# COMBINED LINWOOD/EASTERN INTERCHANGE & US 50/RED BANK INTERCHANGE FOCUS AREA ADVISORY COMMITTEE MEETING NOTES

EASTERN CORRIDOR SEGMENTS II AND III (PID 86462)

## MEETING #3 NOTES

Sept. 7, 2018

**Figure I-29A**  
**ROUNDBOUT AT BEECHMONT AVENUE  
AND LINWOOD AVENUE INTERSECTION**

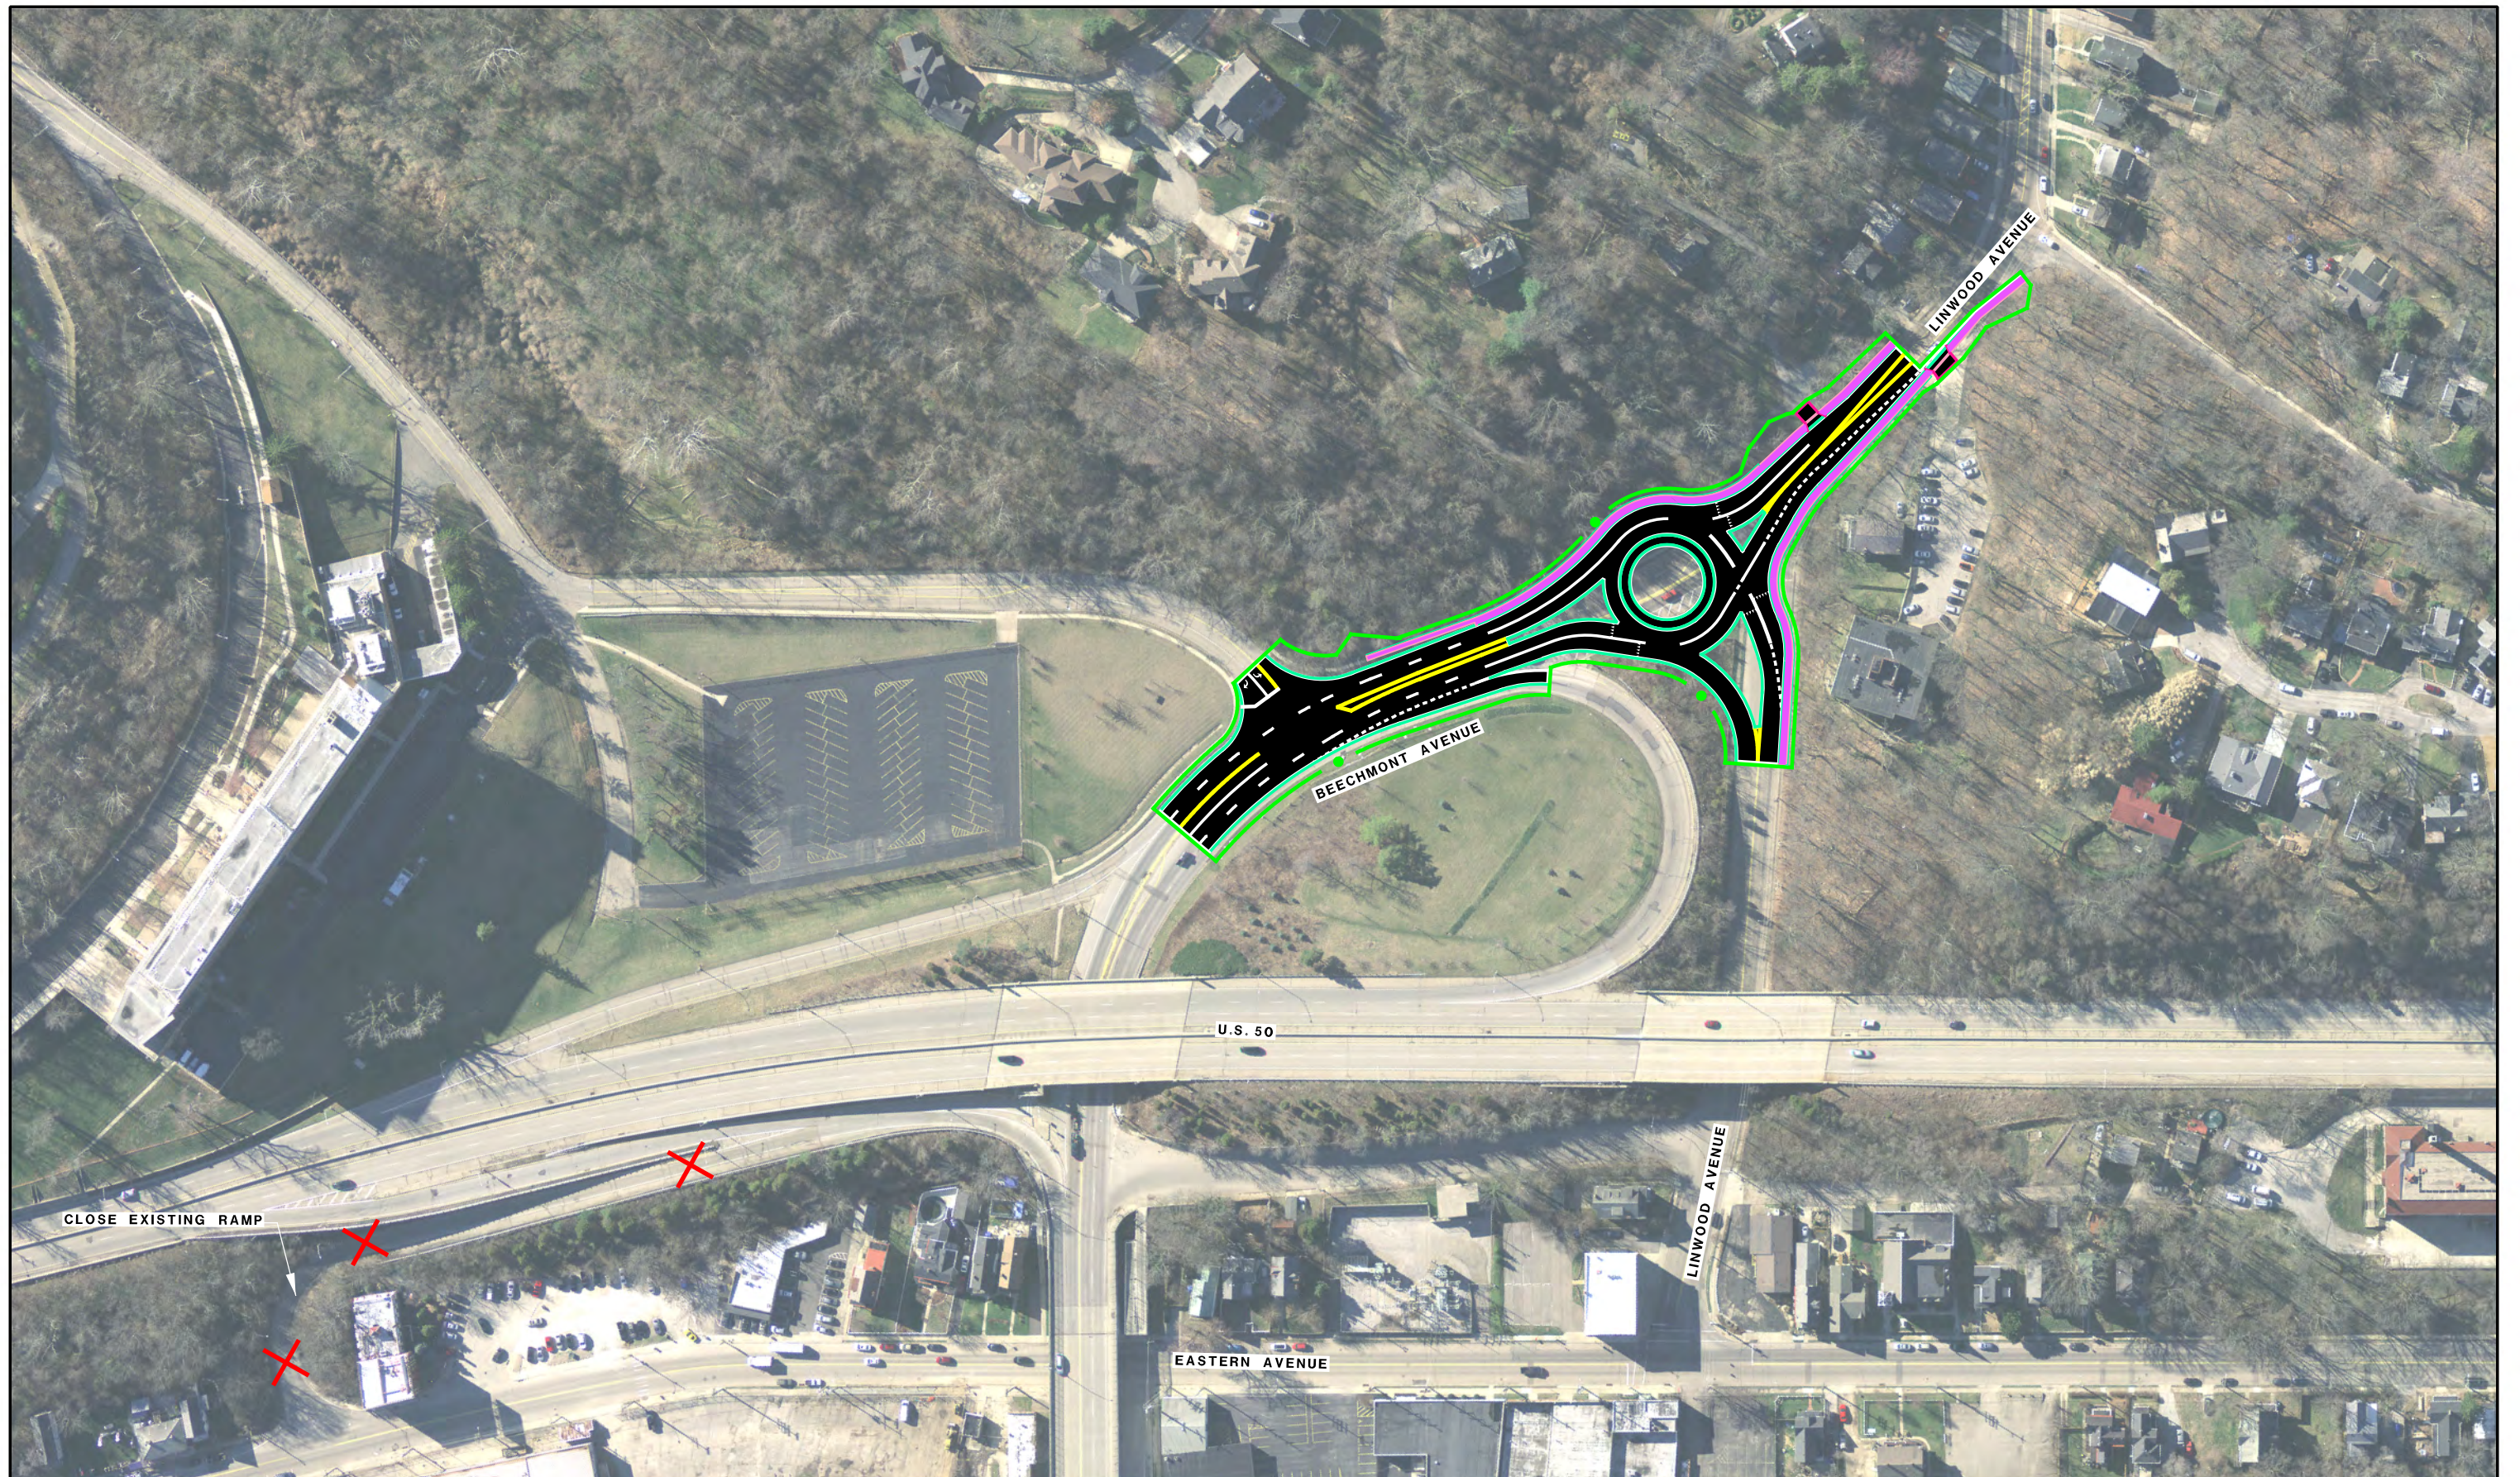
- This concept should be evaluated as an alternative to Concept I-29b. Either alternative would need to be constructed with EW-2 and/or X-3b.
- The roundabout requires two through lanes (one lane won't work); the right lane would essentially serve as a ramp to US 50.

- The concept would require a small retaining wall on the northwest side of the roundabout, which would also require building into the existing hillside.

- During AM peak hours, the roundabout would increase the delay, as vehicles are essentially free flowing today. The projected delay would be roughly between 4 to 9 seconds, which still provides a high level of overall service.

- One Committee member expressed concern regarding pedestrians crossing a two-lane roundabout; however, there are no crosswalks today on Linwood. An island could be constructed in the roundabout for a two-stage crosswalk.

- The roundabout is significantly (nearly 10 times) more costly than the signalized alternative (I-29b), which also works well to improve delays. However, roundabouts provide other safety benefits, such as slowing traffic as it enters the Mt. Lookout neighborhood.

- Advance for public consideration.

**Figure I-29B**  
**SIGNALIZED INTERSECTION AT BEECHMONT  
AVENUE AN LINWOOD AVENUE**

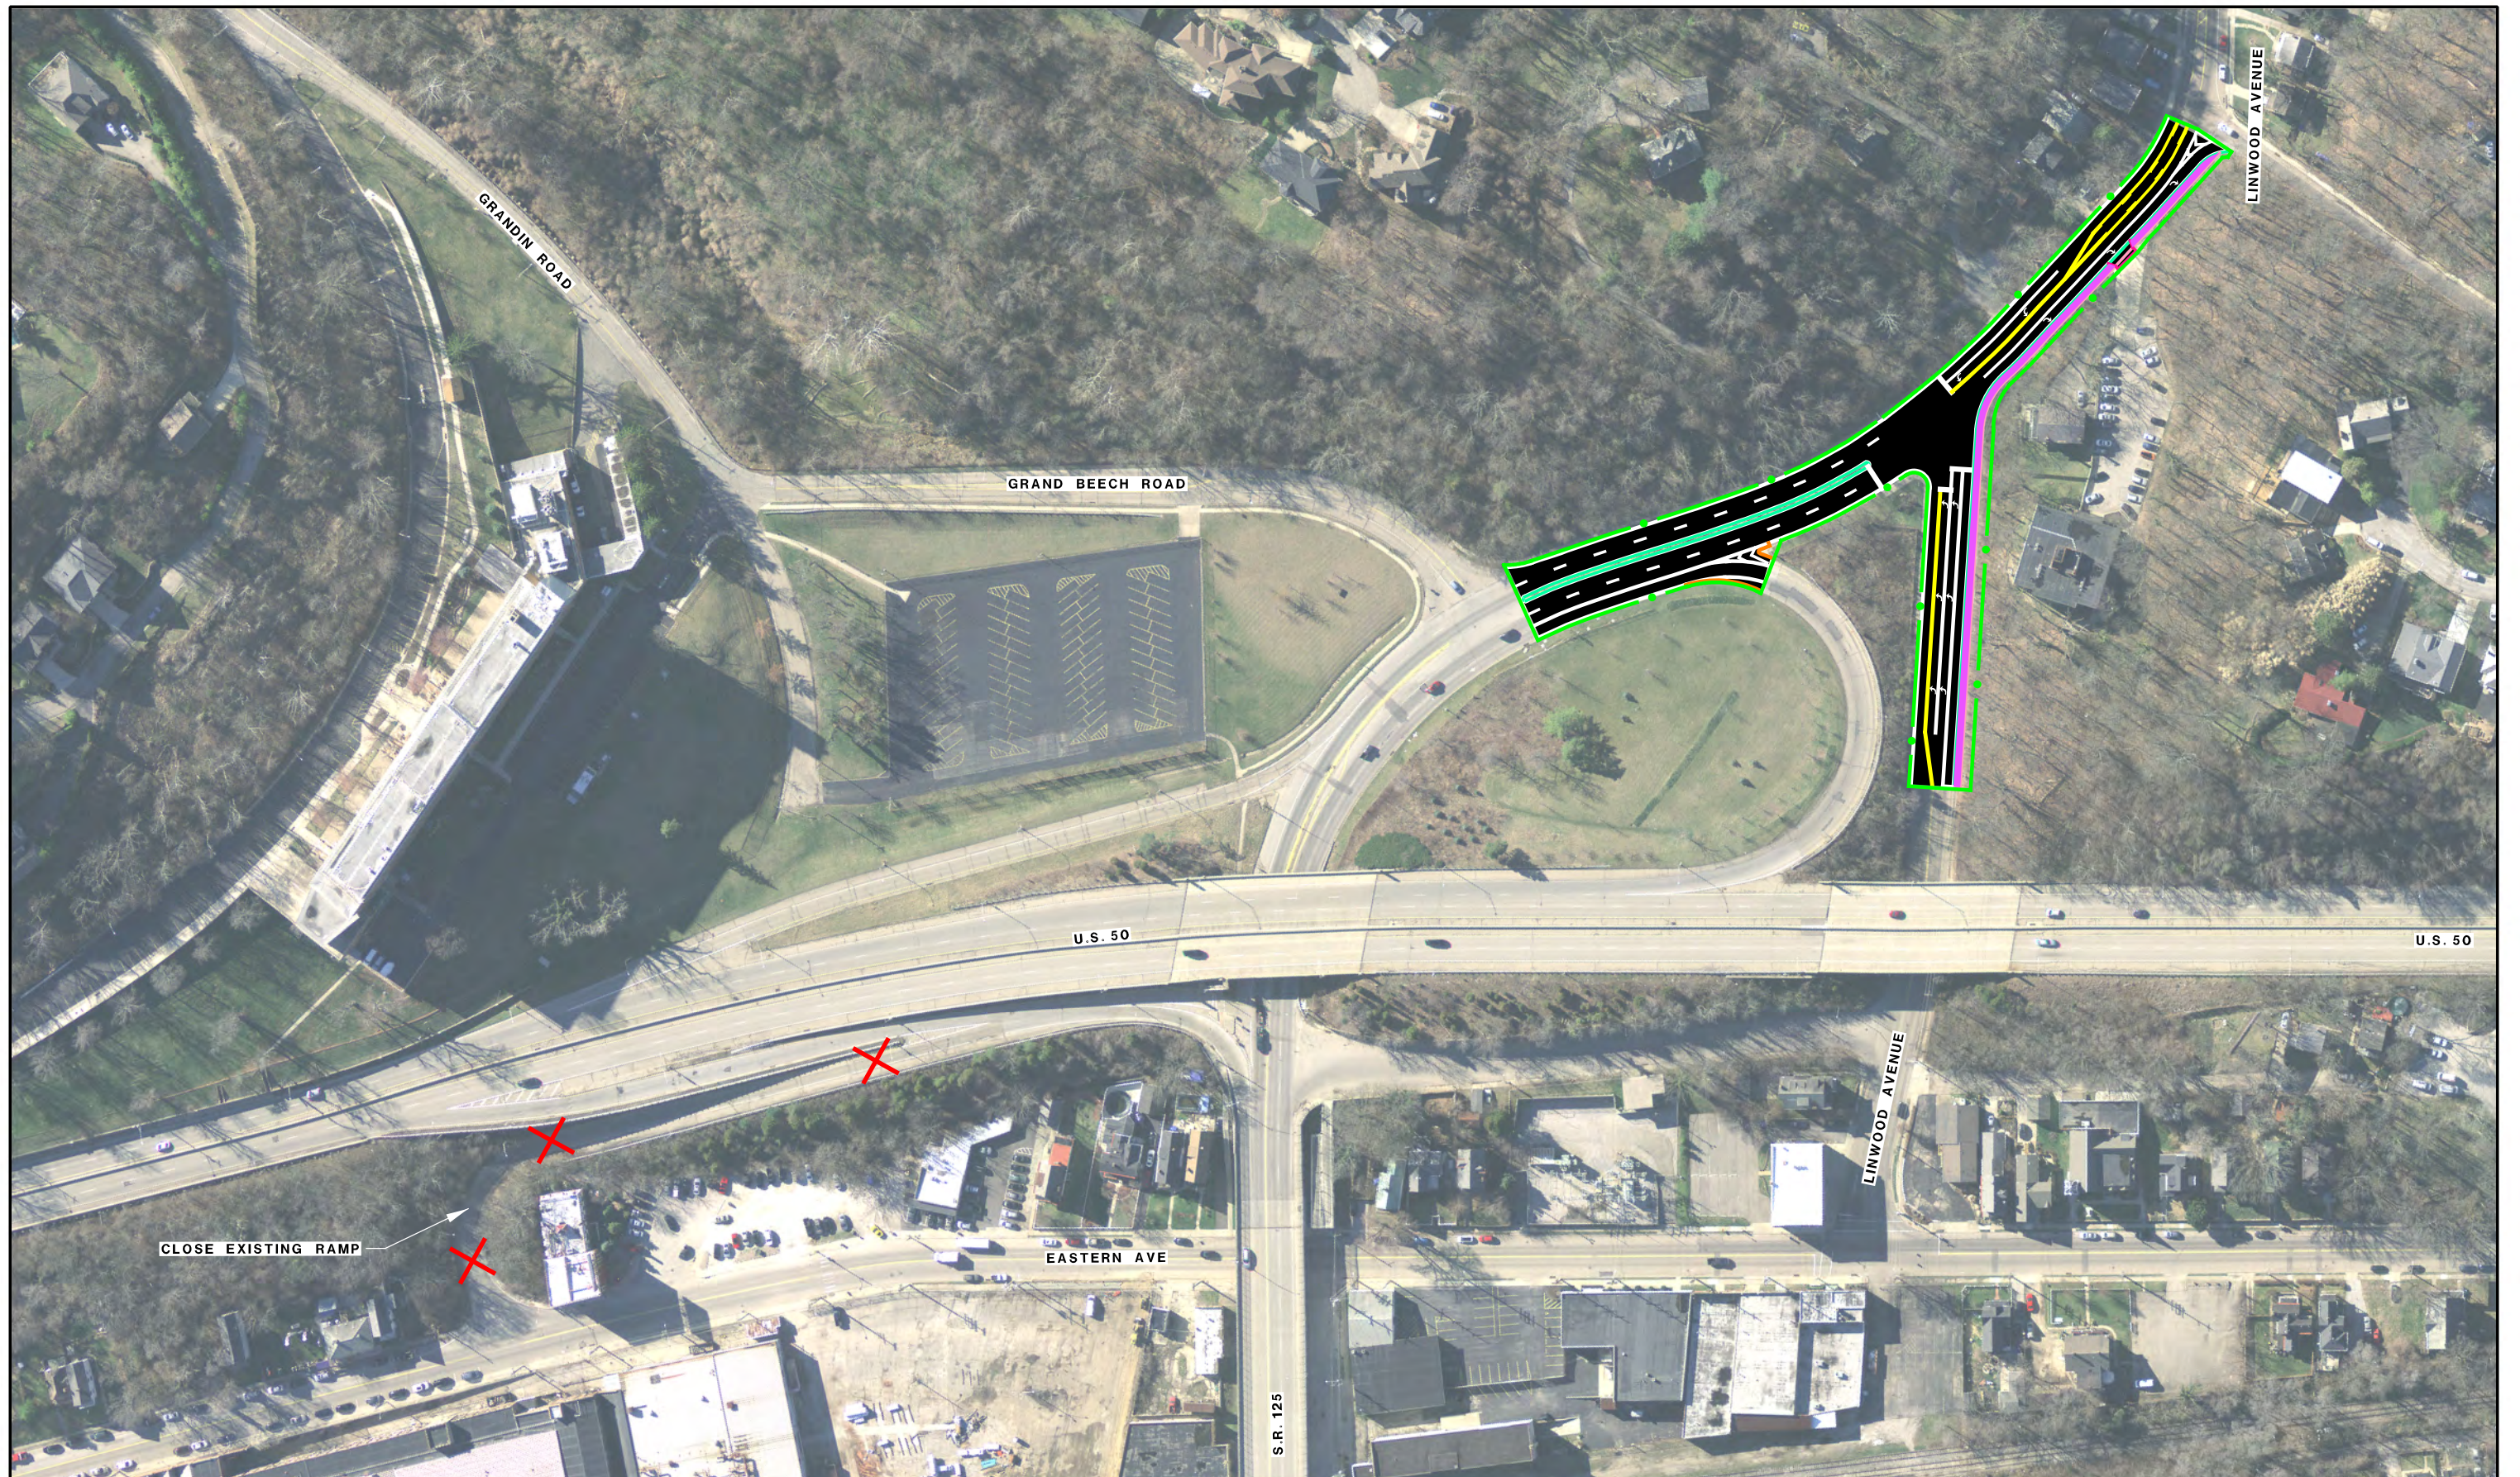
- This concept should be evaluated as an alternatie to Concept I-29a. Either alternative would need to be constructed with EW-2 and/or X-3b.
- Two lanes are required through the signal, though the assumption is a small number of vehicles will use the right lane; a Committee member suggested dropping the second lane after the intersection instead of transitioning to a right-turn only lane to Sheffield. This would discourage cut-through traffic using Sheffield.
- The roundabout (I-29a) is significantly (nearly 10 times) more costly than signalizing the intersection, but also works fairly well to improve delays.
- The signalized intersection could allow for a pedestrian /crossing at the north leg of the intersection across Linwood Avenue, which could be accommodated into the signal phasing.

- Advance for public consideration.
